nDIVISION 26 – VARIOUS REVISIONS

Modify, Section 26 00 01.01 “Owner General Requirements and Design Intent” per the following (deletions are shown struck through and additions are double underlined). Remainder of section is unchanged. (Hyperlinks with be blue underlined with a note describing how many words to include)

PSU OPP STANDARD DETAIL		
TITLE: TYPICAL GROUNDING DETAILS	DETAIL #: 260526-D01	
SCALE: NONE	PAGE #1 OF 1	DATE: 10/20/2014

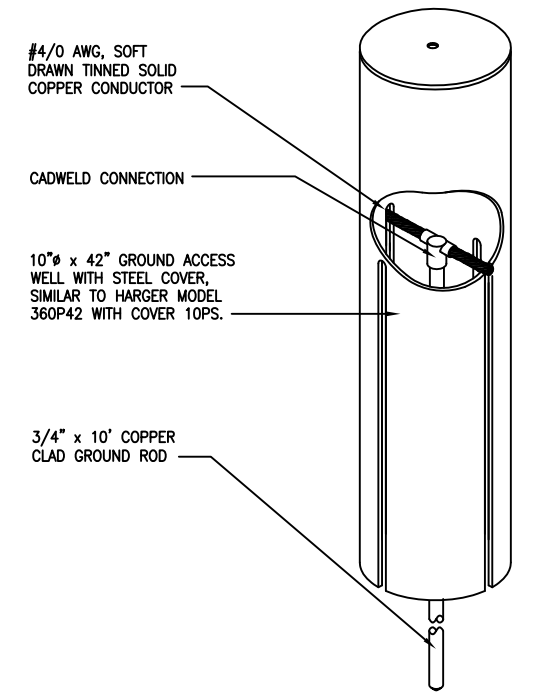
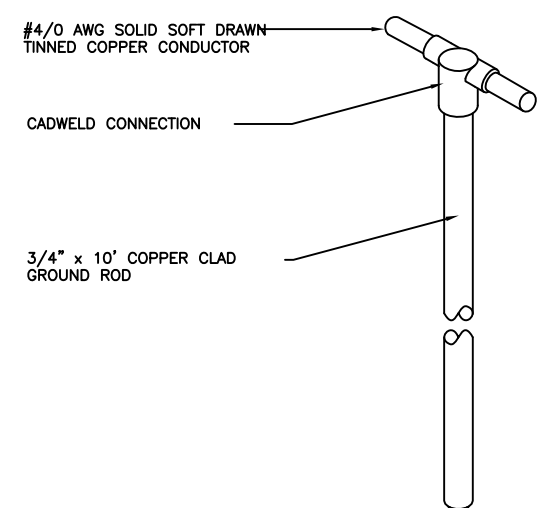
J. Ground connections to the ground bus bar shall utilize a long barrel two lug connection. Single lug short barrel connections are NOT acceptable.

K. Grounding conductors shall be installed in PVC conduit, RMC is an acceptable alternative. However, if RMC is used grounding hubs shall be installed on each end of the conduit and connected to the grounding conductor.

L. Typical CADD details are listed below for the Design Professionals reference:

Added sections J, K & L. J was added to clarify the use of a specific type of compression lug. K was added to clarify that PCV is preferred but RMC can be used if certain guidelines are followed. L was added to hyperlink to PSU’s typical design drawings for reference.
